I am writing to strongly propose a revision to development Case No. SUB-UGA1801.

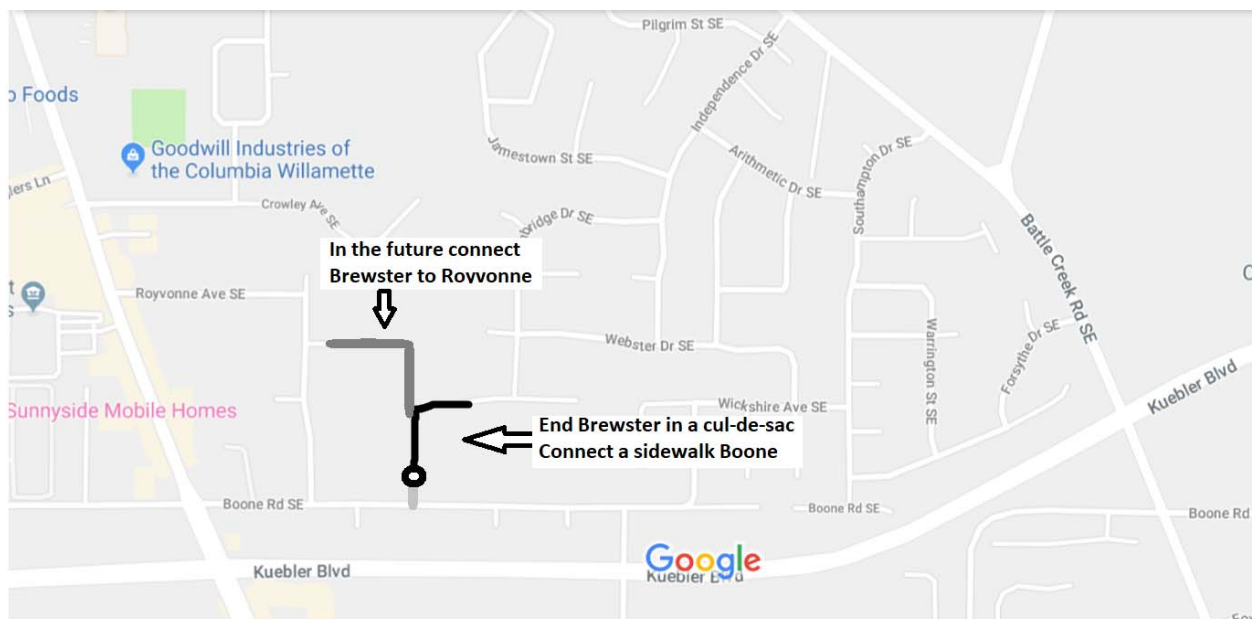
The direct connection of Brewster Ct. to Boone Road creates an attractive shortcut between three major arterials, Commercial St., Kuebler and Battle Creek Rd. Commuters looking to bypass the intersections of these arterials will use this shortcut and significantly increase the traffic through the low use residential Cambridge neighborhood.

1. End Brewster in a cul-de-sac rather than a straight connection to Boone Road. This would protect the residential neighborhood from commuter traffic.
2. Create a pedestrian walkway from the cul-de-sac to Boone Road. This will connect pedestrians and bicycles in the Cambridge neighborhood to Boone Road.
3. In the future, connect Brewster Ct. to Royvonne Ave SE (an existing stub Street) which achieves a similar connection as proposed, but without creating such an attractive shortcut for commuters
